Application No. SDP15-00002 (Site Development Permit) and Administrative Adjustment of Standards

Staff Report

- Applications: Project No. PRJ12-00009
Site Development Permit: SDP13-00005
- Project name: Issaquah Gateway Apartments
- Staff Contact: Amy Tarce, Senior Planner
Development Services Department. 425-837-3097
amyt@issaquahwa.gov

Figure 37. Blank walls along the side of the buildings adjacent to Community Spaces (A) and Circulation Facilities (B)

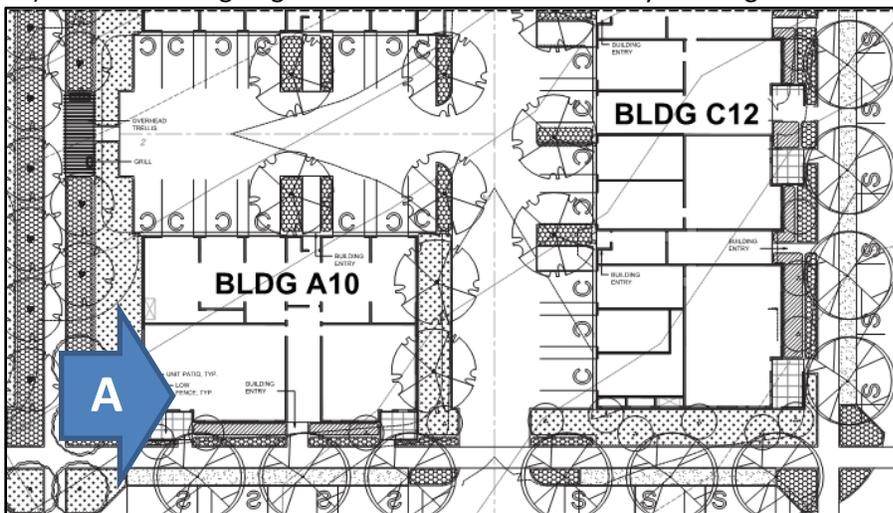
The residential buildings do not have a back side; all elevations are provided with generous windows. However, there are blank walls along the sides where the garages are located. Many of these blank walls are visible from the Through Block Passages and the Neighborhood Streets (see sheets SDP 12 and SDP 13). The northern garage blank walls of the two 5-story buildings are also visible from I-90.

[Condition 87] The garage blank walls of the two 5-story buildings facing I-90 shall be mitigated, with consideration of what is visible from high-speed vehicular traffic along I-90.
